UNITED STATES PATENT AND TRADEMARK OFFICE

Office Action Summary

10/716,260

RUSSO, VITALIANO

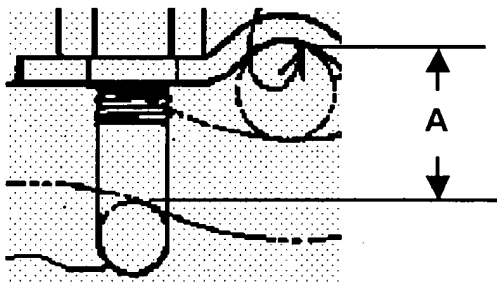
wherein, during the clamping step, the ropes press each other at their crossover area, because of the displacement of contacting rope strands, reducing the overall thickness **A** (Figure 10b shown below with annotations) of the first and second ropes pressed together to 1 to $\frac{4}{3}$ of the rope diameter (thickness **A** is approximately $\frac{4}{3}$ the diameter of rope **3,4**) in such a way that the ropes are forced to lie substantially in the same plane at each knot of the net (Figures 9-10b).

wherein the unique piece has a given distance **A** measured between a tangent line at an intrados of an arch of the bridge element and the plane defined by tangent lines at the intrados of curved bases of the first U element and the second U element, and

wherein the give distance is between 1 and $\frac{4}{3}$ of the rope diameter (Figures 9-10b).

wherein the given distance is between 1 and $\frac{4}{3}$ of the rope diameter (thickness **A** is approximately $\frac{4}{3}$ the diameter of rope **3,4**; Figures 9-10b).
